ADDENDUM #6

North Hancock Road Extension Phase IIIA and IIIB
FPN No. 435515-1-58-01; Project No. 2014-11
Bid No. 14-0030

This addendum is being issued to make the following changes, corrections, clarifications and additions to the bidding document. The information in this addendum modifies and changes the original bidding documents and takes precedence over the original documents. **Receipt of this addendum shall be acknowledged by the bidder by signing and dating the appropriate line on page W-11 of the bid proposal.** Failure to acknowledge this addendum may preclude consideration of the bid proposal for award.

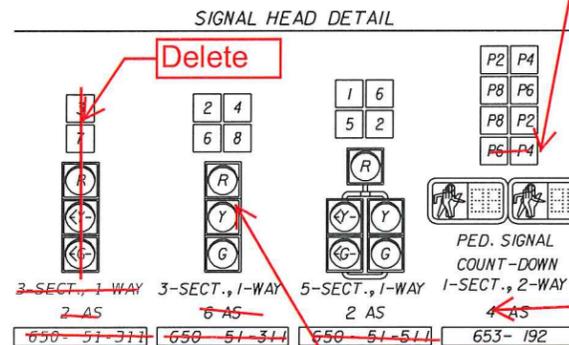
- A5. See revised redlined plan sheet, Signal General Notes and Signal Pay Items & Quantities included in Addendum #6.
- Q6. The answer to Q2 on Addendum #2 stating all PED Signals & Detectors are to be mounted on poles. Please specify which type pole, i.e. aluminum, concrete, steel, with breakaway or without. Also, an additional PED Pole is to be added to the SW corner of the N. Hancock & Old Hwy 50 intersection. Is the Ped Signal to be a Single (653-191) and the existing proposed signal on the same corner to be changed from a Double (653-192) to a Single (653-191).

- A6. All pedestrian poles are to be Aluminum Pedestal 646-1-11. See Signal Pay Items & Quantities sheet. For the traffic signal East Old Hwy 50, sheet 301, the additional pedestrian pole is to be single and the existing shall be changed from a double to a single. The original location for the P4 was not correct. See redlined plan sheet 301.

Please note the pay item number for the 3 section signal head should be 650-1311; and the five section head 650-1511

Delete P4 & P6 S/b one way

Delete

Pay item - 646-1-11_1 EA

Pay item - 646-1-11_1 EA

Should be 3 section signal head 650-1311

Pay item - 646-1-11:-1 EA

Should be 3 section signal head 650-1311

Add phase 3 & 7_s/b pay item 650-1311- 8 AS

See Note 1

Note 1: Sheet 301 - All existing signal must remain in operation at all times until Mast Arm Traffic signal is Operational.

Note 2: Sheet 301 - The original plans call for 2 way Standard P-4 & P6 pedestal pole. The pedestrian pole (P4 & P6) shall be 1 way with additional conduit, cable and Pedestal Assembly

Sheet 301: Conduit Addendum

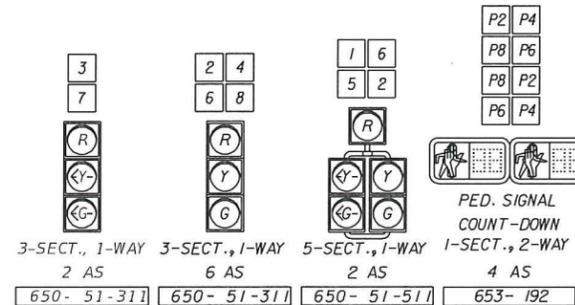
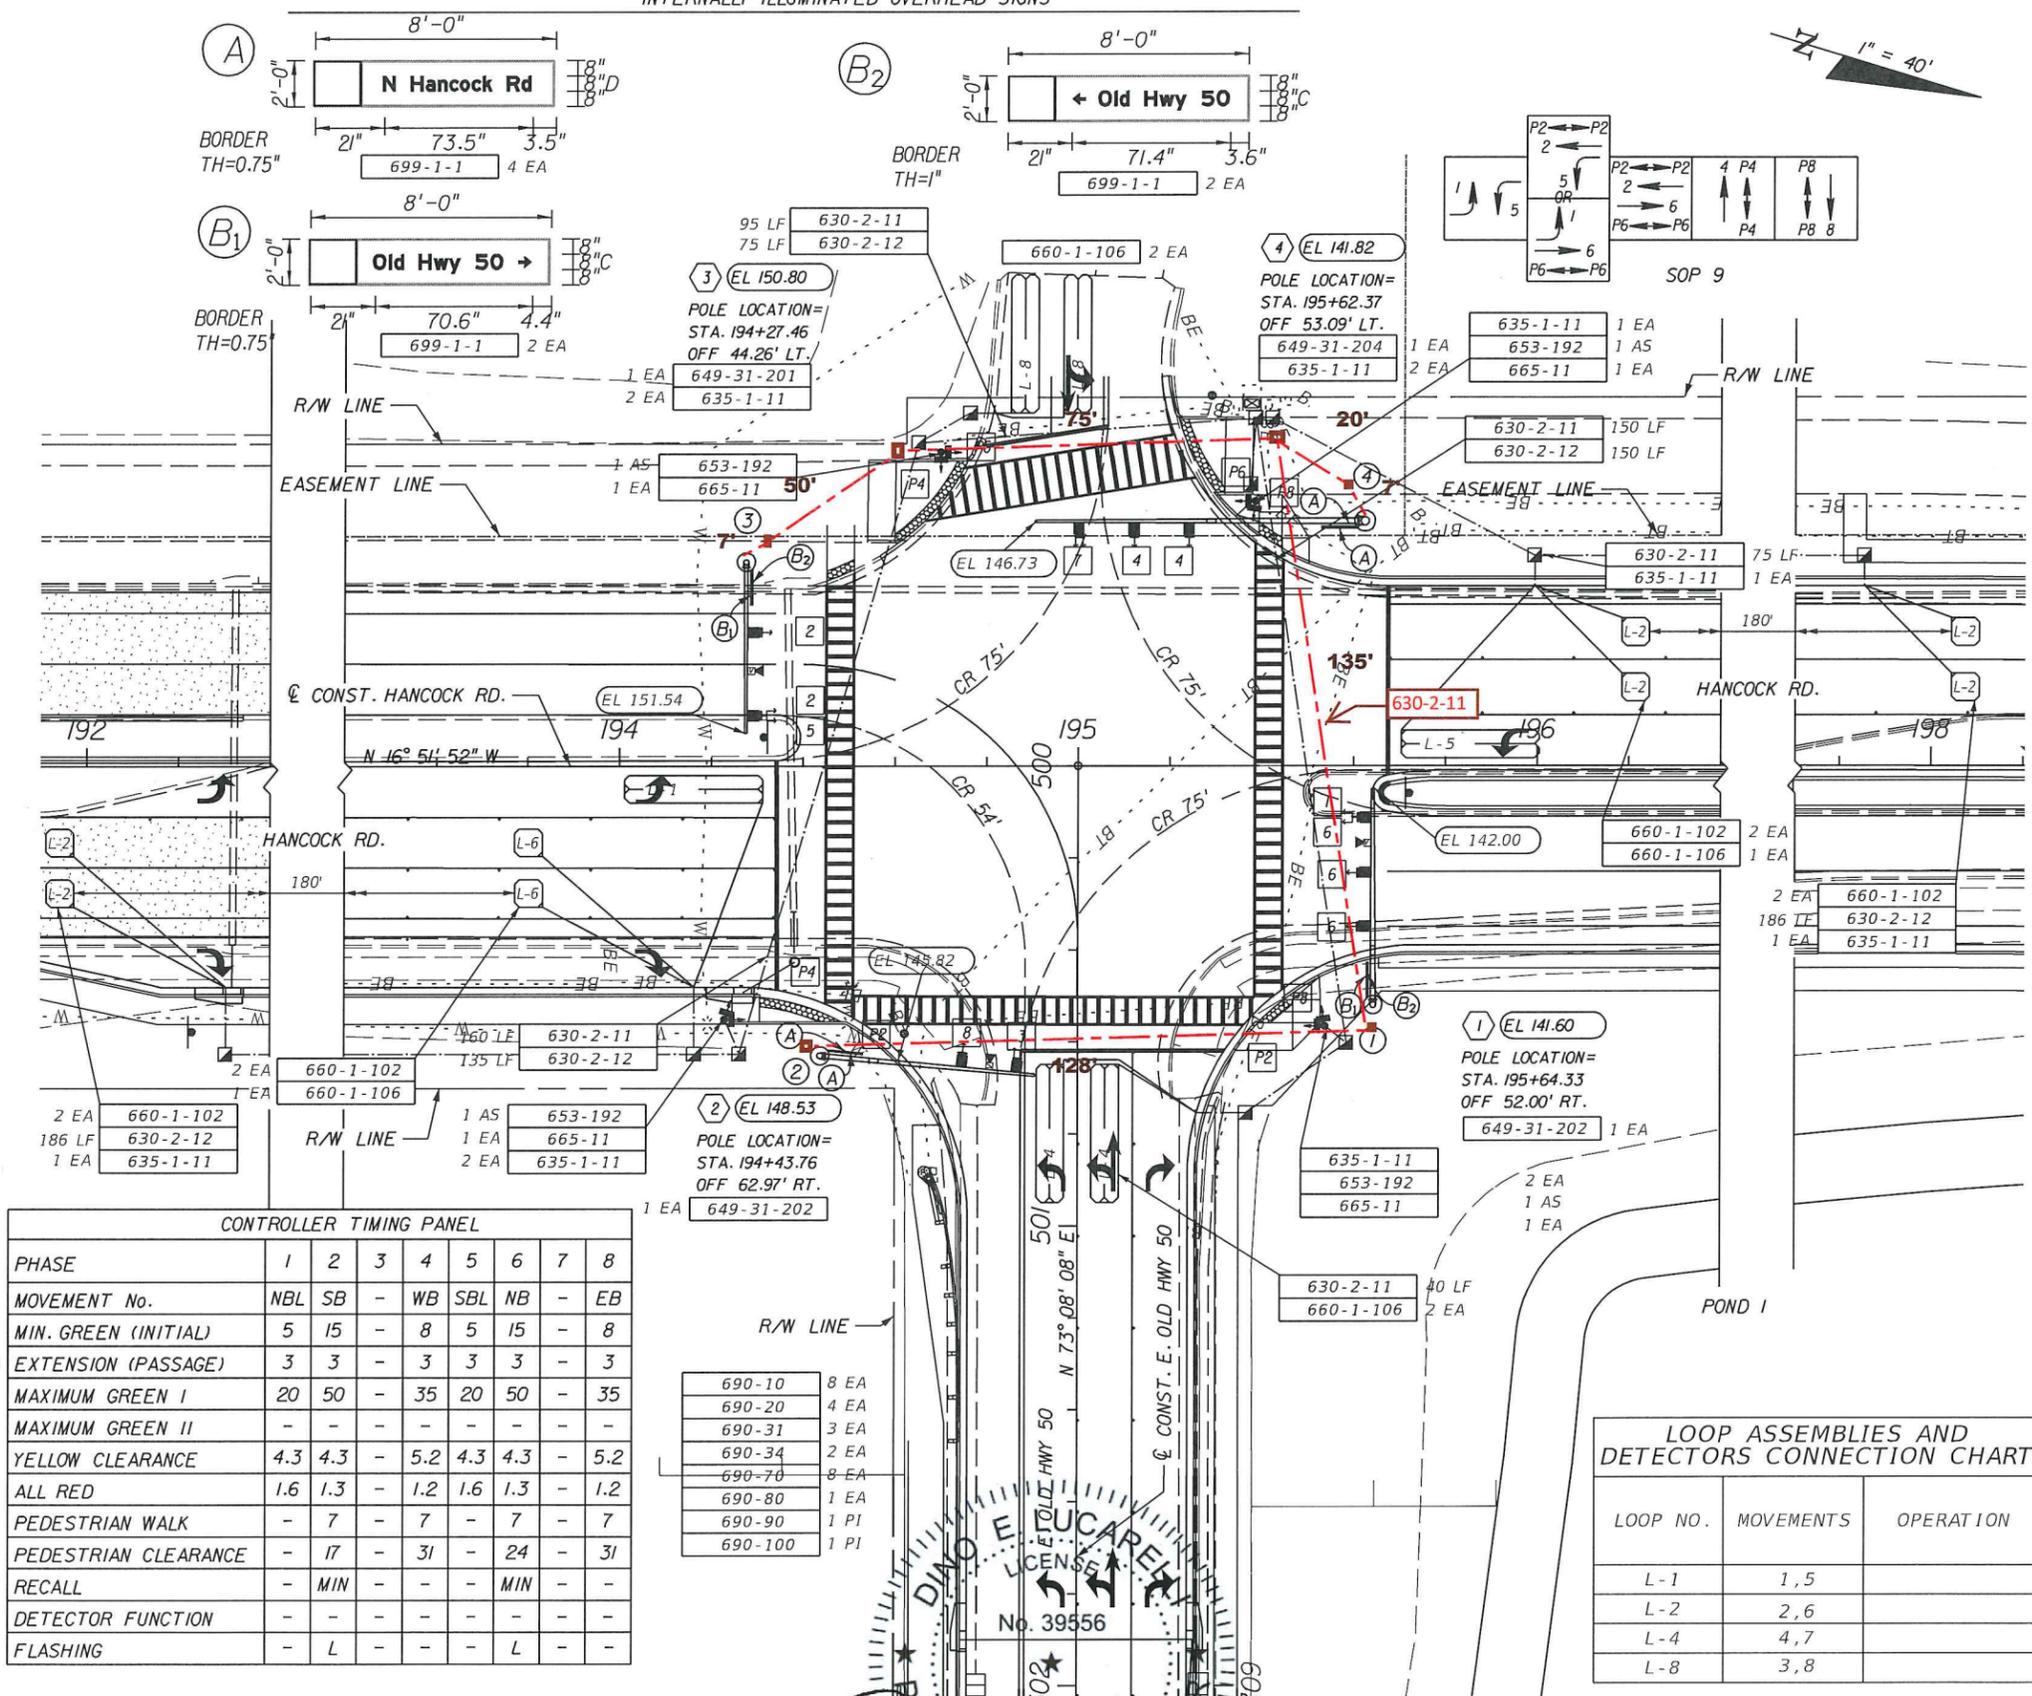
- A7. The contractor shall bid and install electric service and electric service wire to make the traffic signals operational. See notes and Signal Pay Items & Quantities. The traffic signal at East Old Hwy 50 is existing and operational with power. This traffic signal is to be removed and replaced, (sheet 301). The existing traffic signal shall remain operational until the new mast arm signal is operational. For the traffic signal West Old Hwy 50, (sheet 302) see note: On Sheet 35 of the plans there is an existing power pole at station 38+60 L. This is the closest power location to the proposed signal at West Old Hwy 50 and Hancock Rd. Power shall be brought from this location to serve the traffic signal. The approximate distance to the controller cabinet is 1050 LF.

Pay item - 646-1-11_1 EA

Should be 3 section signal head 650-1311

Pay item - 646-1-11_1 EA

Should be 3 section signal head 650-1311

Pay item - 646-1-11_1 EA

Remove

Should be P2 & P8

Sheet 302: Conduit Addendum

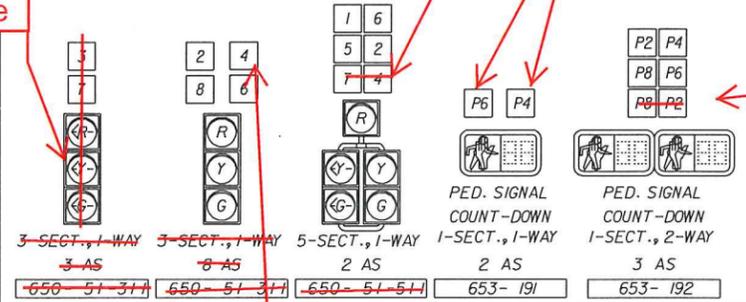
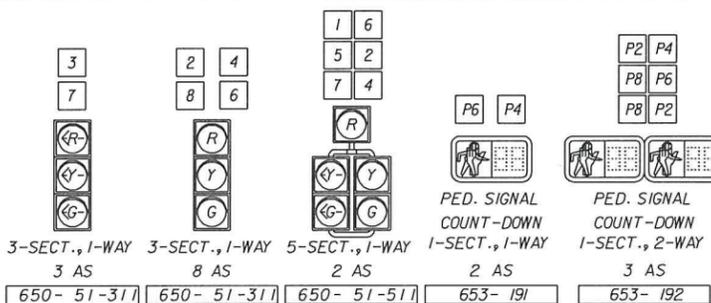
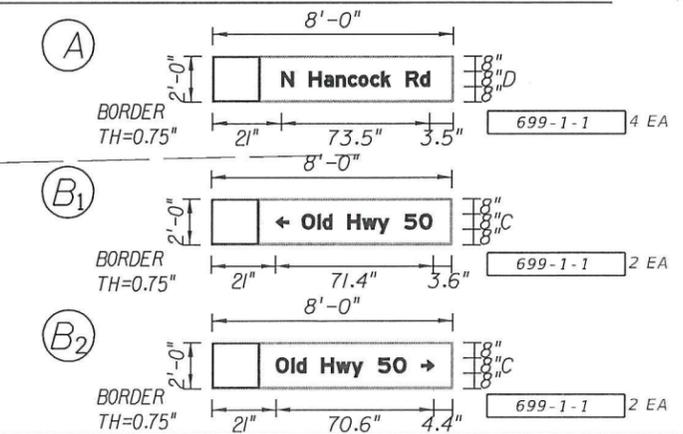
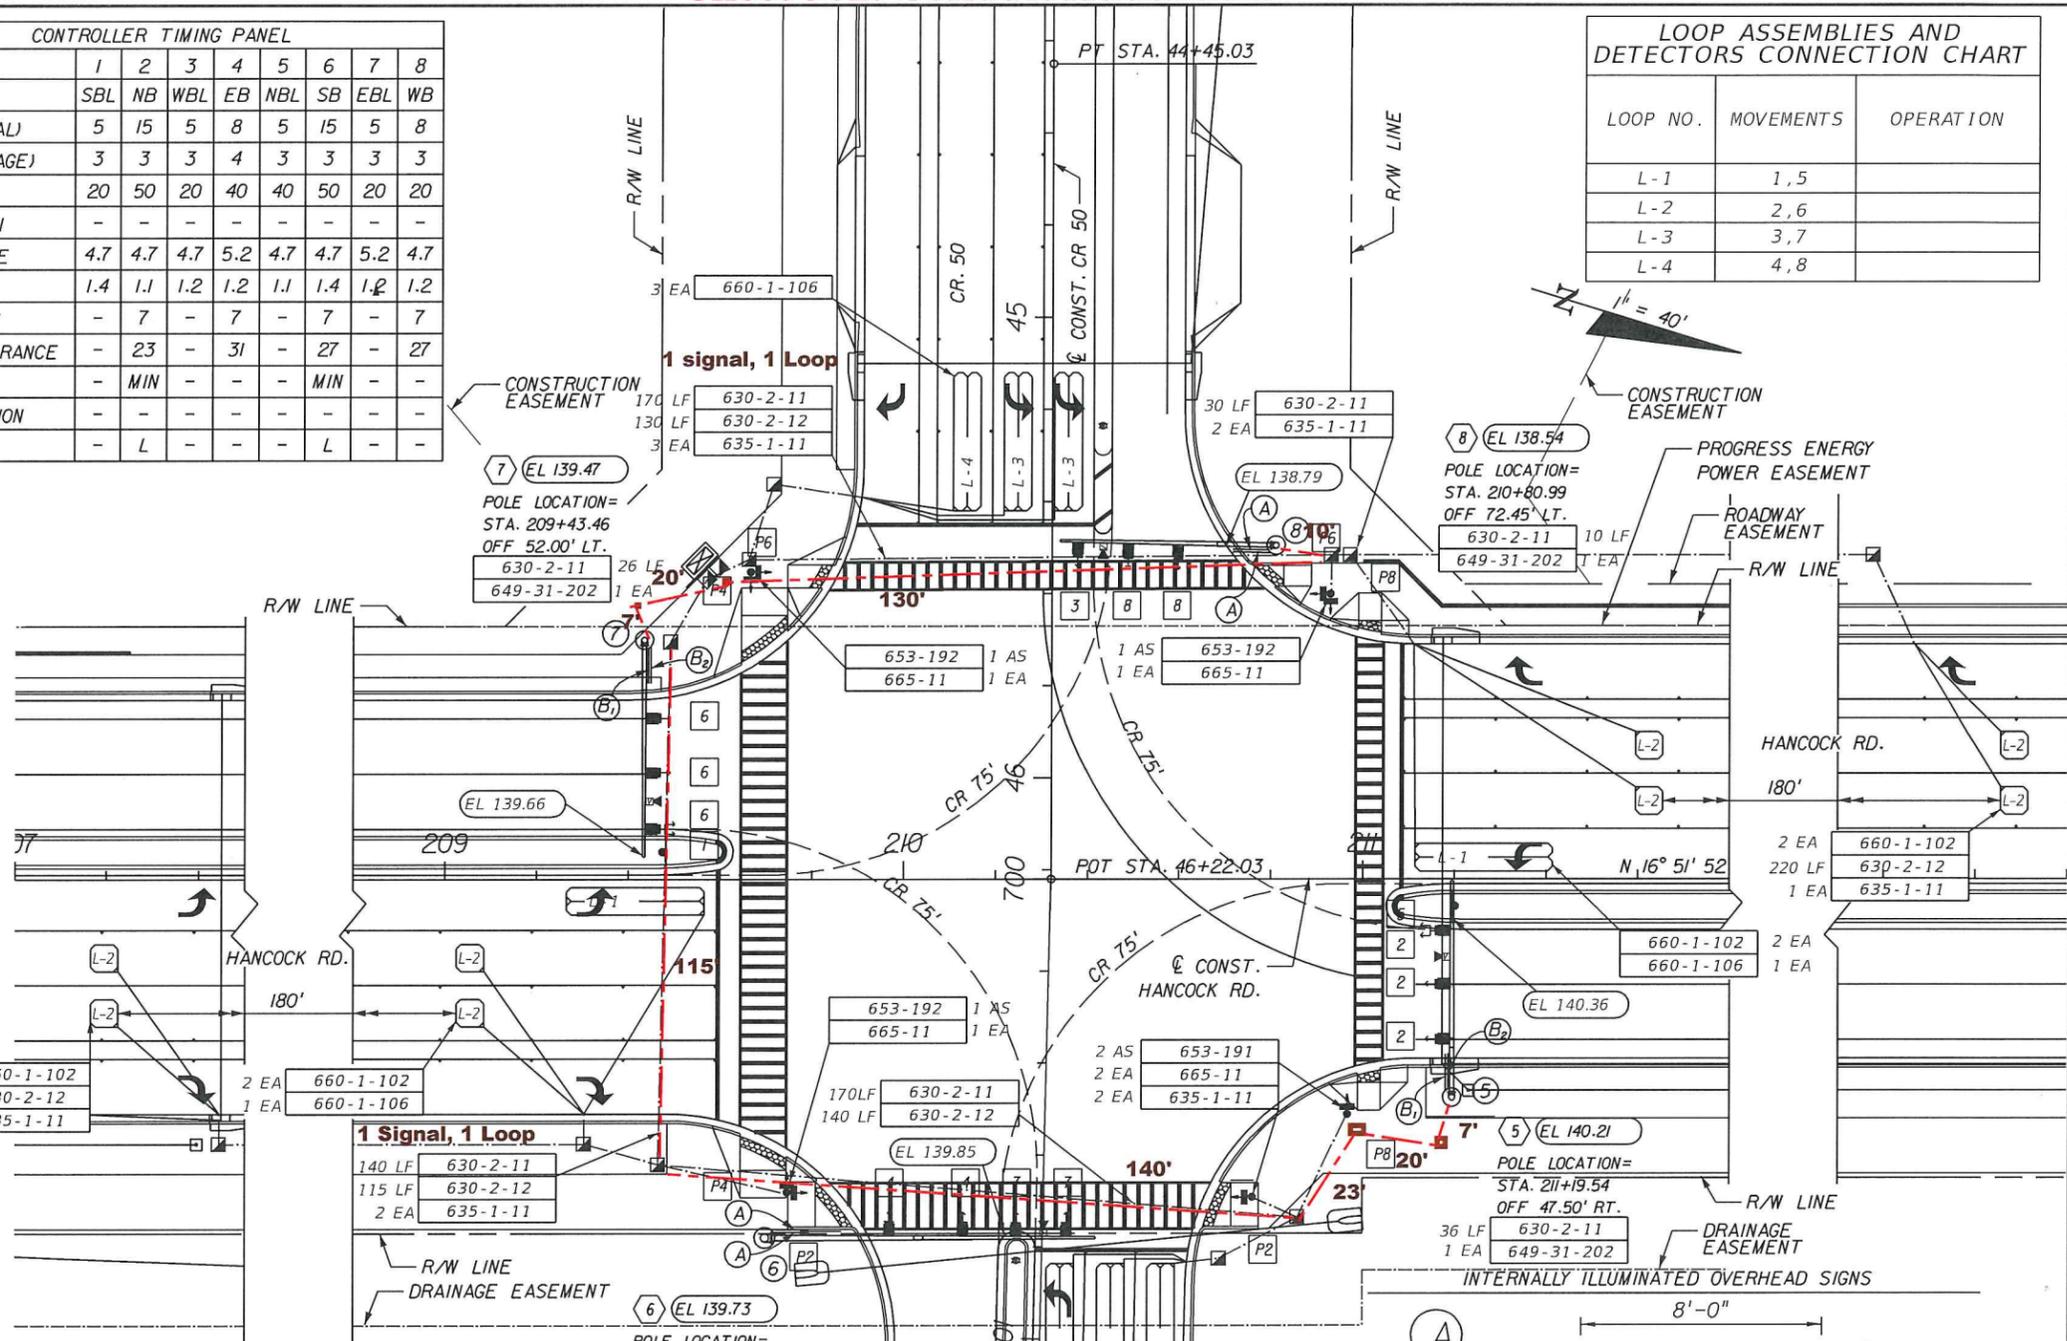
Pay item - 646-1-11_1 EA

Pay item - 646-1-11_1 EA

Should be P6 & P4

Remove

REVISIONS	DATE
Add phase 3 & 7_s/b pay item 650-1311- 11 AS
